INSTABILITY PIER

RE: INSTABILITY OF PIER EXCAVATION,
GHOST RIVER BRIDGE, WP 73-60

REPORT ON INSTABILITY OF PIER EXCAVATION
GHOST RIVER BRIDGE, MATHESON, ONTARIO.

REPORT ON INSTABILITY OF PIER EXCAVATION GHOST RIVER BRIDGE

GOLDER & ASSOCIATES	
CONSULTING CIVIL ENGINEERS	
DATE: SEPT. 20, 1962 SCALE: 1" TO 10'-0"	
MADE J.A.	CHKD. APPD. FIGURE 1

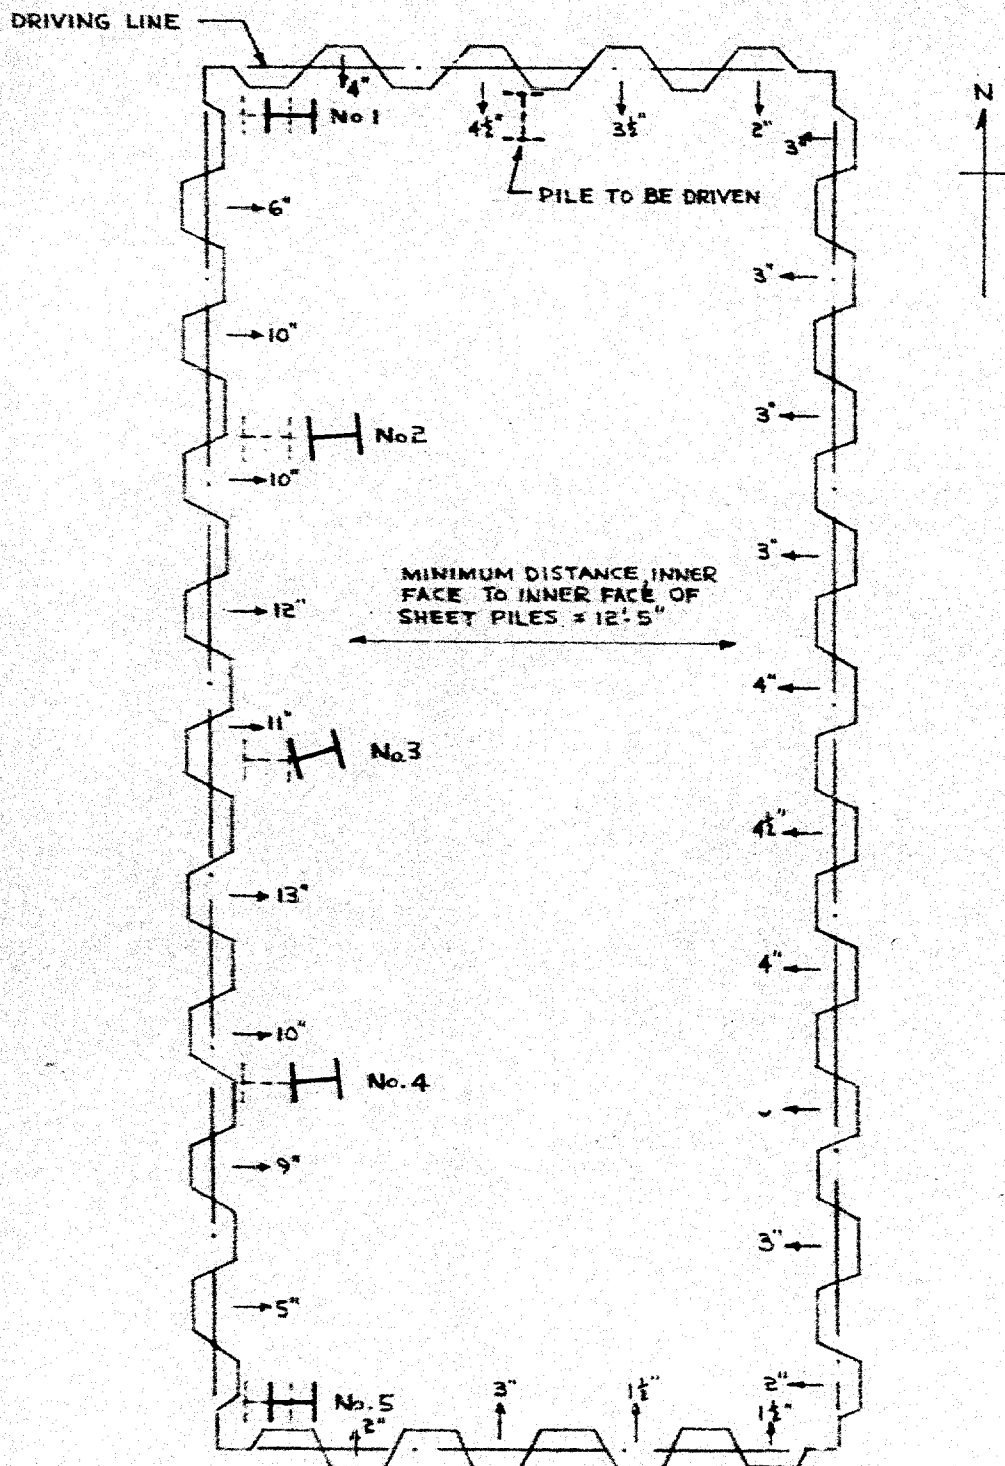
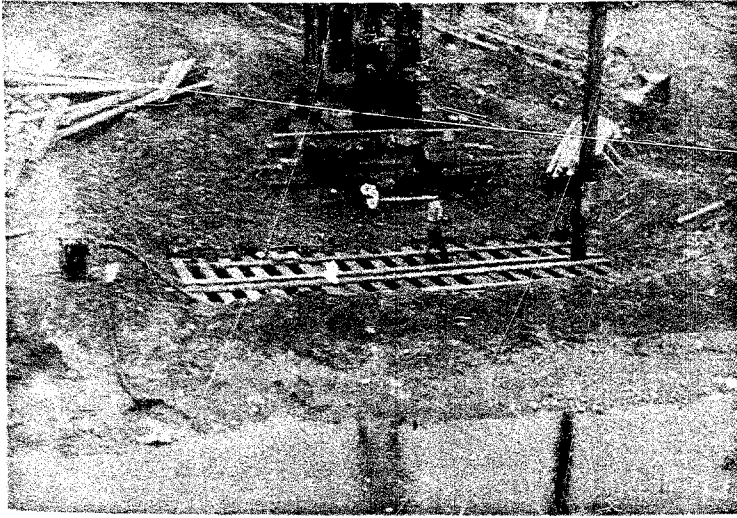
Following the driving of sheet piling around the approximate perimeter of the proposed west pier, the placing of an upper strutting frame and excavation to about 8 feet depth, five H-section steel foundation piles were driven within the excavation along the west face adjacent to the sheeting. During driving and immediately after these piles were driven some inward deflection of the sheeting at the base of the excavation was apparently observed. This deflection was not measured as the excavation was then flooded by a rapid rise of Ghost River. Upon pumping out the excavation several days later the sheet piling was observed to be deformed quite markedly, the foundation piles had also moved and two had been twisted from their original alignment and the base of the excavation was 'boiling' in several locations. The sequence of events as compiled from records at the site by Mr. R. Marin, D.H.O. is given in Appendix I. Significant details of the excavation, the site conditions and the measured deformation of the piles is shown on Figures 1 and 2. The maximum displacement of the sheet piles was along the west face of the excavation and was approximately 12 inches. Part of the waler flange at the west face of the sheeting was buckled; a photograph of this is shown on Figure 4.
